3070-74-S

S E R V I C E N O T E

Agilent 3070 Series 3 Board Test Systems

POSSIBLE ELECTRICAL SHOCK HAZARD

Picture of Hubbell connectors

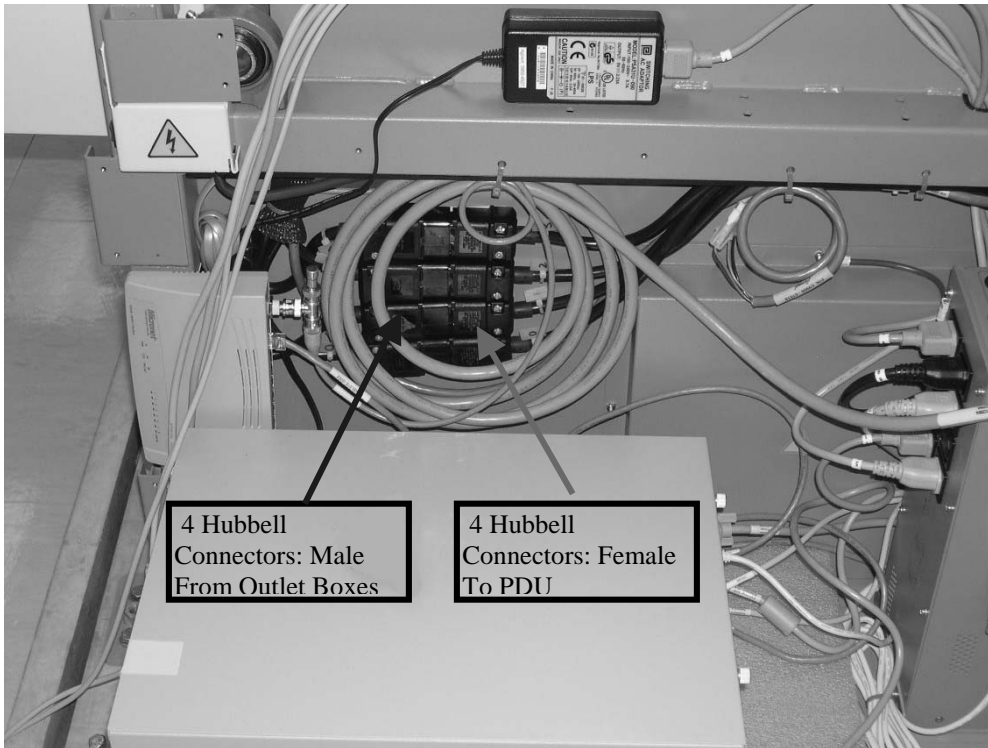
- The solution involves replacing suspect power outlet boxes with new assemblies. The outlet box assembly consists of an outlet box with 3 receptacles, a 3 conductor power cord and an IEC320 Plug (Hubbell H320P). A service note compliance sticker will be attached to the system upon completion of the replacement and testing of the outlet box. The outlet box is attached to the 3070 frame via two Torx T20 type screws (0515-1922). The two Torx screws (0515-1922) will be reused on the new outlet box assembly. The Hubbell connector mates with a plug (see picture below) connected to the PDU E1135C.

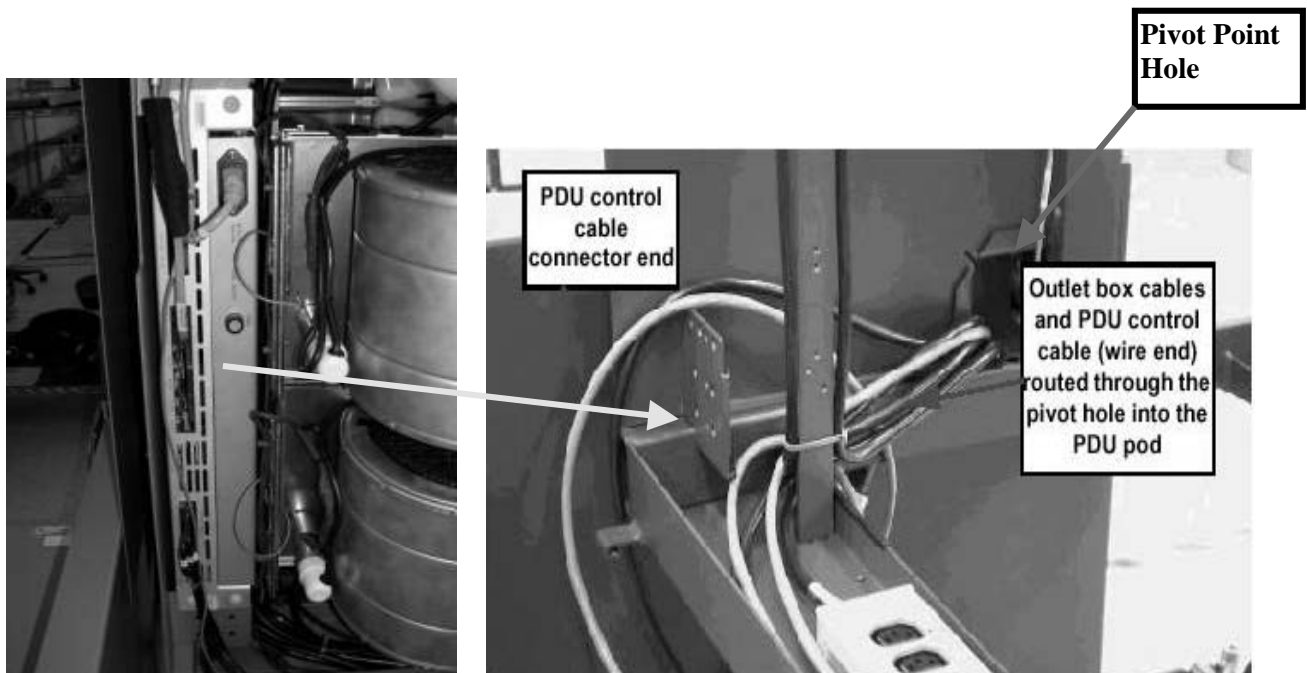
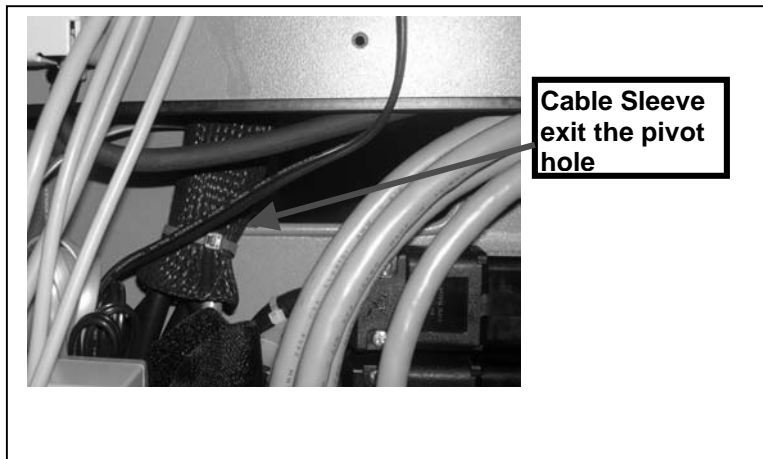
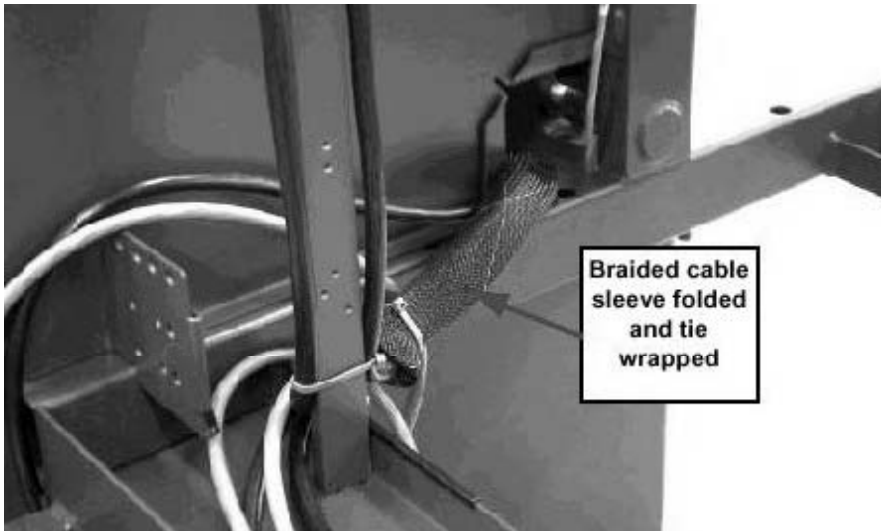
12. Slide a 460mm braided cable sleeve (Agilent PN 0890-1937) over the five cables from the pod side of the testhead.

13. Pull the tie wraps snugly around the cable sleeve at both ends.
 14. Replace all the tie wraps that were cut previously
 15. Verify the ground terminal connection on the outlet box is less than 0.5 ohms when measured to an ESD grounding point.
 16. Reinstall system card
 17. Reinstall module mother board
- Caution:** Do not connect the MPU, Fan or Test Head Rotation Motor until verification of AC Voltage at outlet boxes.
18. Reapply power to the PDU. Measure the line to neutral voltage at each receptacle. The measured voltage should be:
 1. **90V to 110V for a 100V system**
 2. **99V to 132V for a 110-120V system**
 3. **180V to 228V for a 200-208V system**
 4. **198V to 264V for a 220-240V system**
